PROJECT RECORD DRAWINGS

College of Southern Maryland

FIRST FLOOR PLAN – PLUMBING
DEMOLITION
COLLEGE OF SOUTHERN MARYLAND WELLNESS CENTER
LA PLATA, MARYLAND

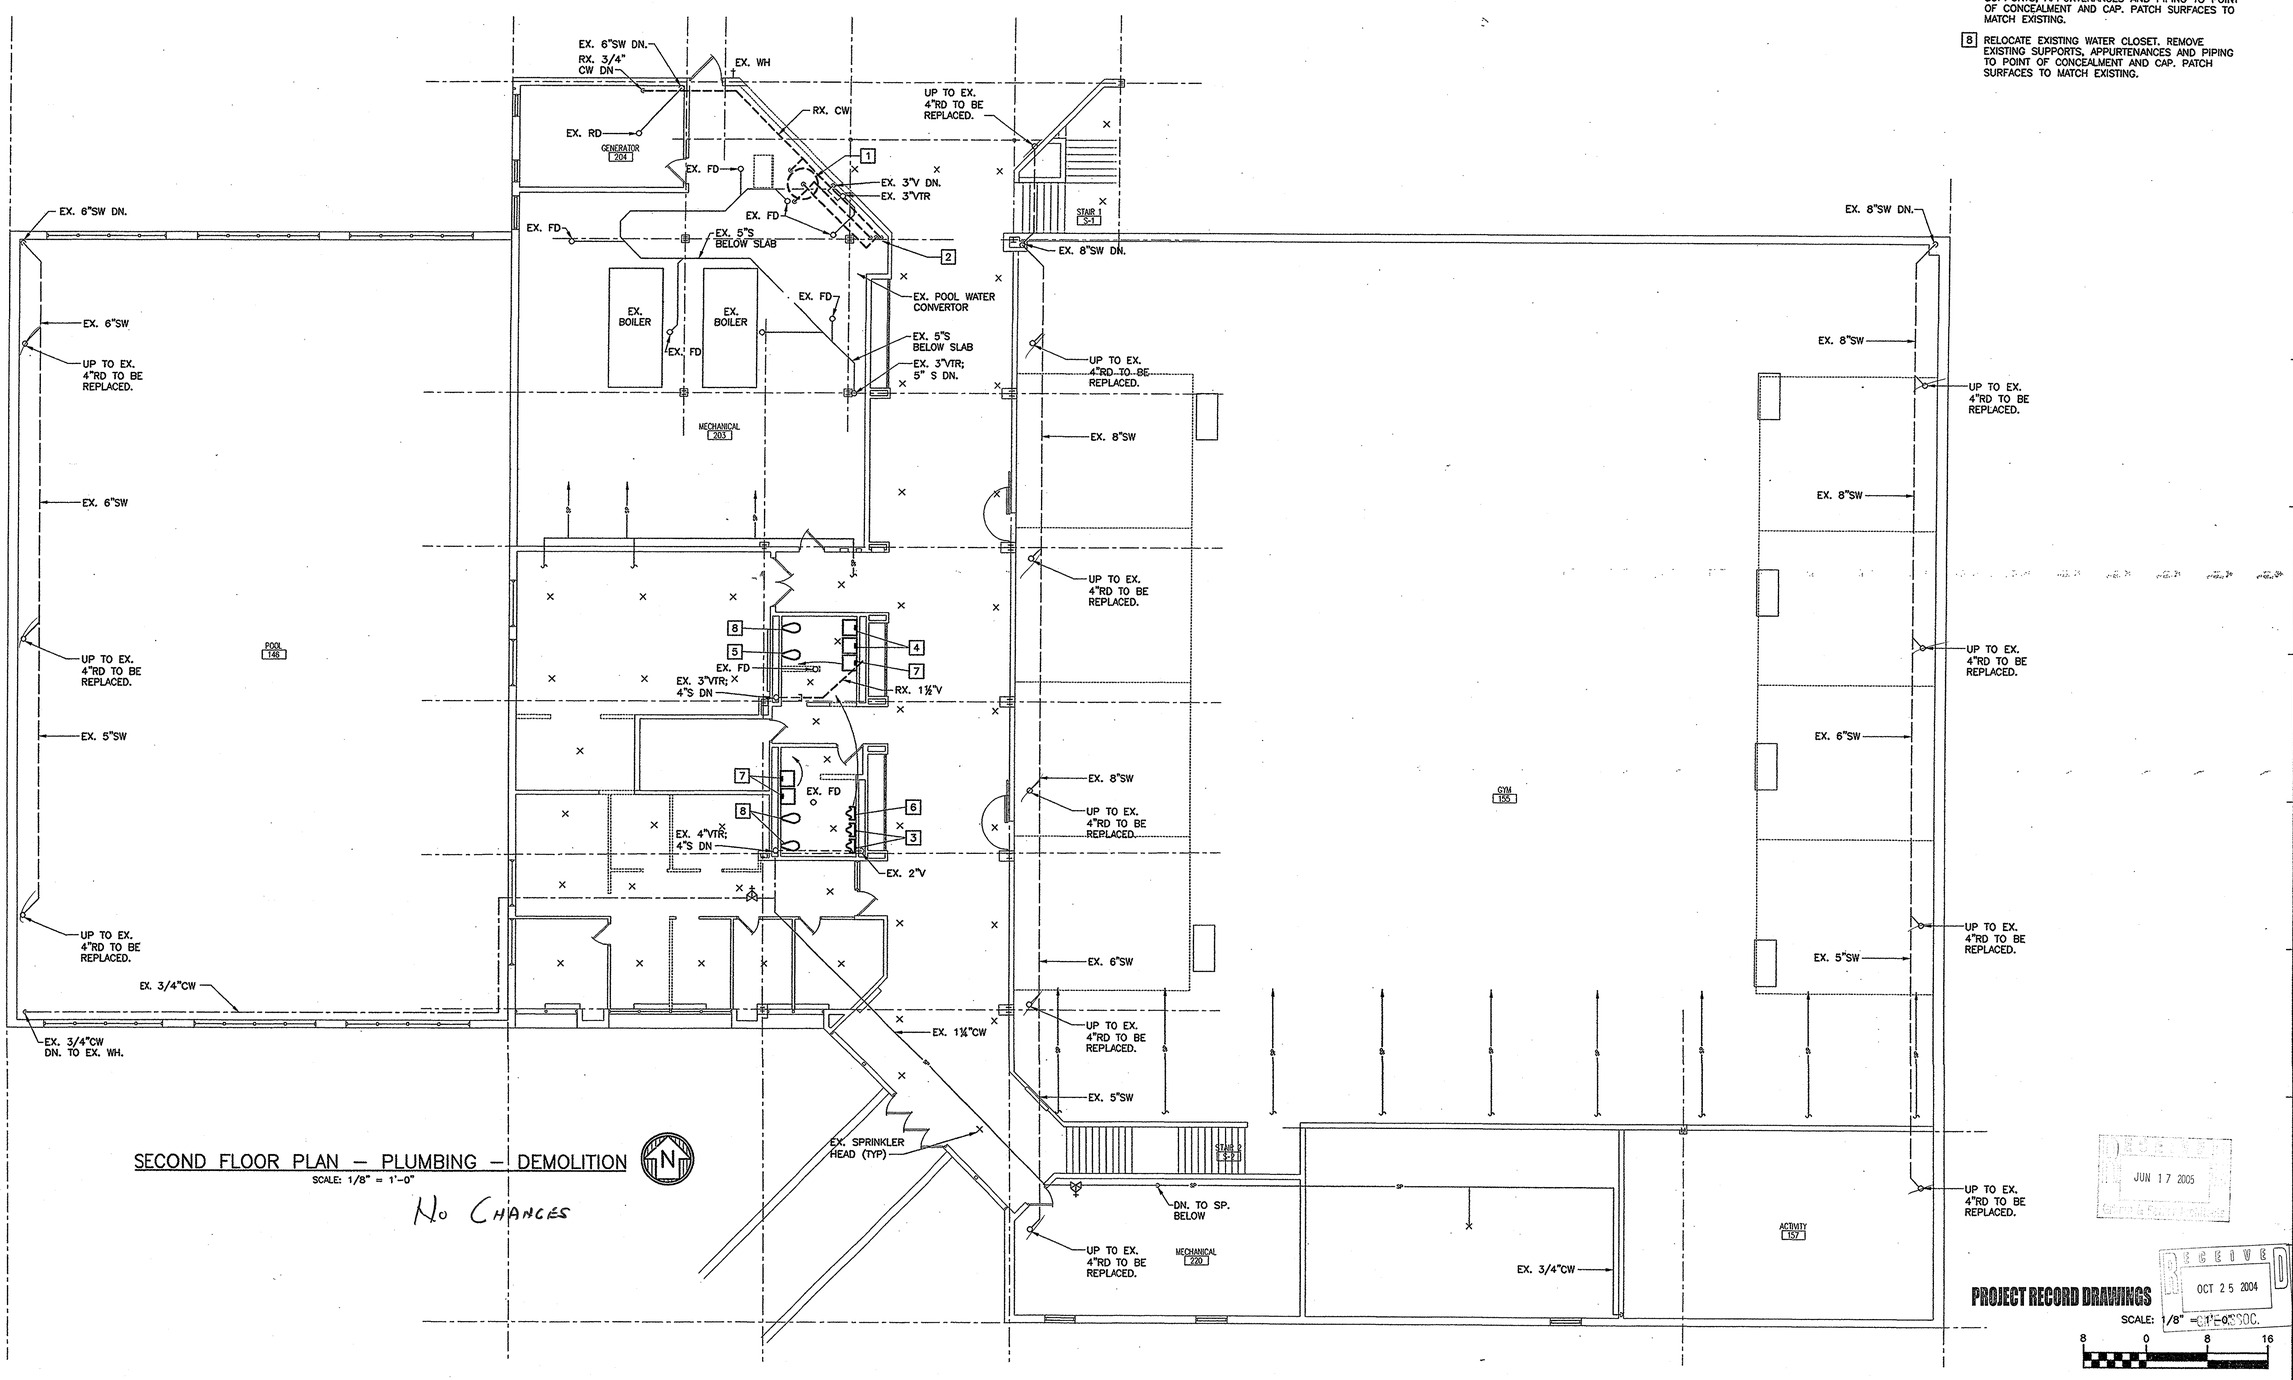
4"SW INV. EL. 185.00± REFER TO CIVIL DWGS. FOR CONTINUATION.
4"SW DN. AT 45°
4"SW DN. TO BELOW SLAB
4"SW UP TO RD
NEW IN-LINE FIRE PUMP IN VERTICAL IN PIT. PROVIDE ADDITIONAL PIPE AND FITTINGS AS REQUIRED AND CONNECT TO EX. PIPING AND WIRING. AVAILABLE FLOW AND PRESSURE IS 250 GPM AT 73 PSI.
EX. POOL PUMP IN PIT
PROVIDE TAMPER SWITCH ON EX. SHUT-OFF VALVE
EX. 6" F BELOW GRATE FROM POOL
REPLACE ALL SPRINKLER HEADS IN POOL FILTER ROOM
3" CW SERVICE BELOW GRADE. REFER TO CIVIL DWGS. FOR CONTINUATION.
4" DRAIN TILE ON FOOTING. INV. EL. 185.00±
EX. 5"SAN
3"CW DN.
EX. 3"CW
TS
WATER DETECTOR IN PIT
SPRINKLER TO ADDITION AREA
BELOW SLAB
EX. JAN.
EX. 3"CW
TS FS
OTS OFS
NEW
SR-4
2"CW UP
2"HW UP
3/4"HWR UP
EX. 6"SW
EX. WH
EX. 3/4" CW UP
EX. 6" SW UP
EX. 6"SW
BACKFLOW PREVENTER
EX. 3"FD
EX. 2"V DN.
P-7B
EX. 1" POOL MAKE-UP
EX. 5" SAN. BELOW SLAB
EX. 3"V UP
SR-3
EX. V
EX. FD
TEMPERING VALVE #2
P-7C
P-5
DRYER
BELOW SLAB
EX. 5"
4"FD
WASHER
P-7
P-7A
ABV. CLG.

(17) DOMESTIC HOT WATER GENERATOR/STORAGE TANK PIPING DETAIL

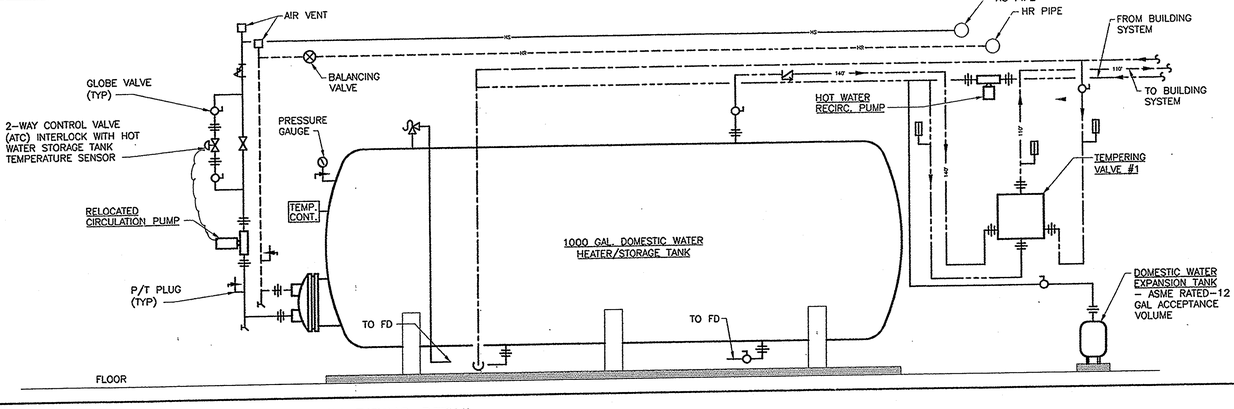
DOUBLE WALL COPPER TUBE TANK HEATER MODEL ~~DW12-60, 104 SQ. FT AREA OF HEATING SURFACE;~~
BOILER WATER: EWT 190° LWT 170° 44 GPM PD 3.8 FT.
TANK WATER: EWT 40° LWT 140°
RECOVERY RATE: 22 GPM
